**World Forum for Harmonization of Vehicle Regulations****Working Party on Passive Safety****Sixty-seventh session**

**UN Regulation No. 127 (Pedestrian safety)****Proposal for the 03 series of amendments to UN  
Regulation No. 127 (Pedestrian Safety)****Submitted by the expert from the European Commission on behalf of  
the Drafting Task Force\***

Figure 12  
Typical and untypical fracture behaviour of mineralic glass

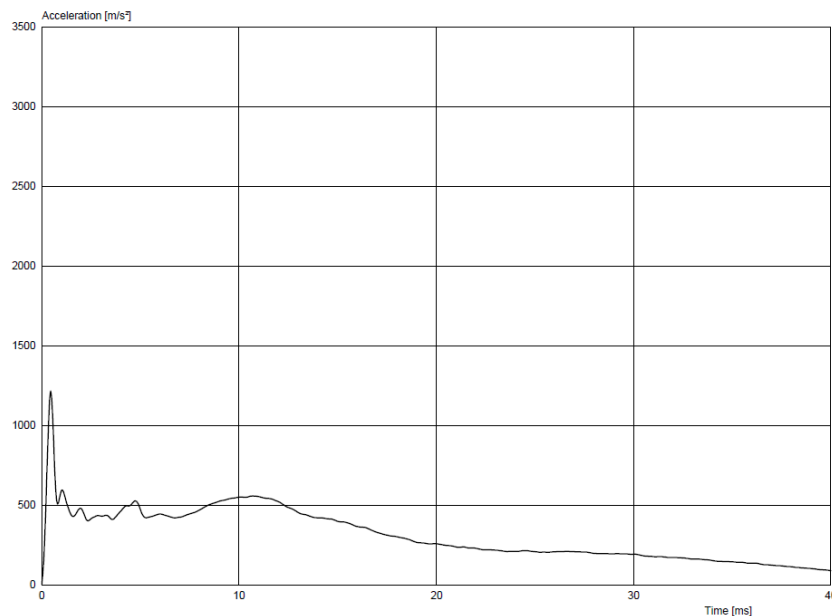
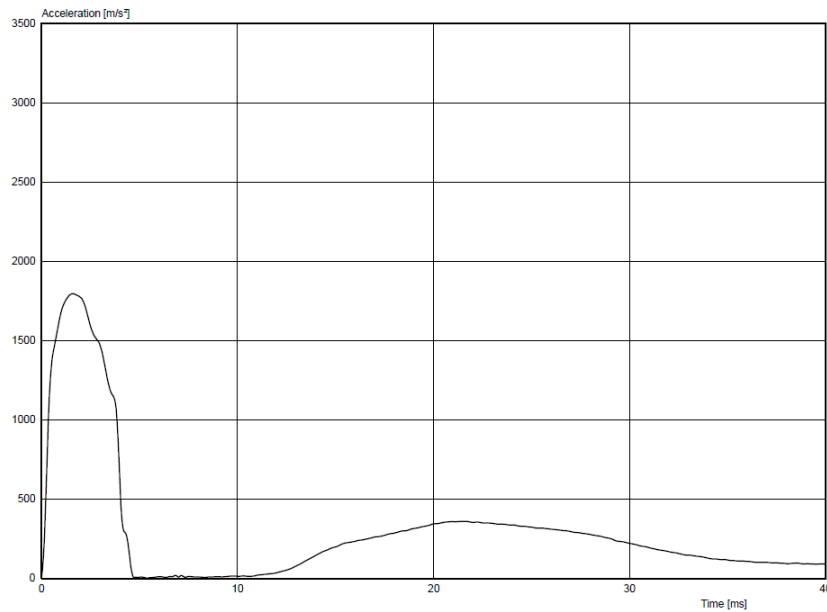
- 2.45. "*Opaque obscuration*" means any area of the glazing preventing light transmission, including any solid black windscreen-printed area, but excluding any shade band, dot-printed area, text or graphics.
- 2.46. "*Shade band*" means any area of the glazing with a reduced light transmittance, excluding any opaque obscuration.
- 2.47. "*Untypical windscreen fracture behaviour*" is the situation that upon impact by the headform, the integrity of the windscreen remains for more than [1] milliseconds without fracture, as a visual criteria of high speed videos, or which appears as an untypically lengthy peak with more than [500]  $\text{m.s}^{-2}$ , or combination of peaks, in the time/acceleration plot for more than [3] milliseconds (examples are shown in graphs 1 and 2 of figure 12).
